**DESCRIPTION:**

Hall Probe K for F1A Magnetic Transducers with the naked Si chip is a very thin (0.5mm) and long (47mm) single-chip integrated 1-axis Hall-Probe. It measures magnetic fields perpendicular to the probe plane (By).

Figure 1. The dimensions of K Hall probe and Cable (Module H)

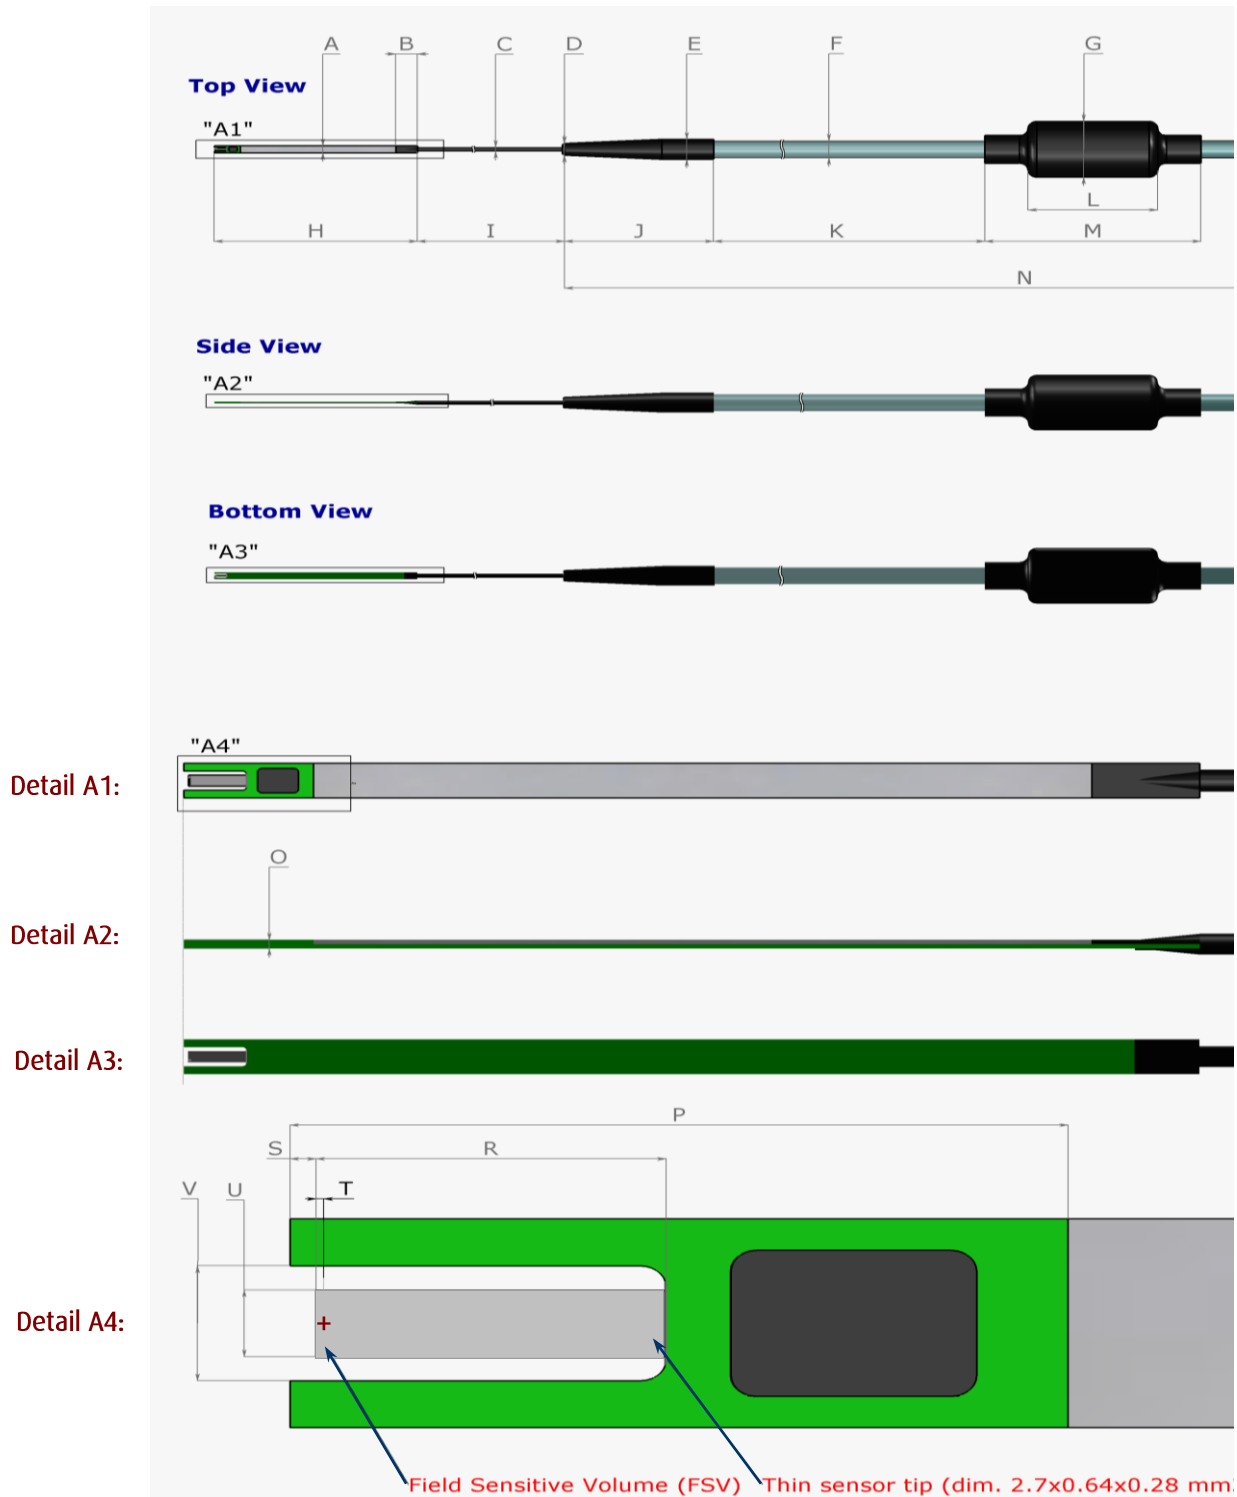
\* The "O" dimension and tolerance for the probe thickness is applied for the K Hall probes manufactured after January 2012. Those probes are labeled with Serial numbers beginning from **xxx-12**.  
The older K probes with thickness of 0.6 (+0.1/-0.0) mm (labeled with the Serial Numbers up to **xxx-11**) are not longer in production.
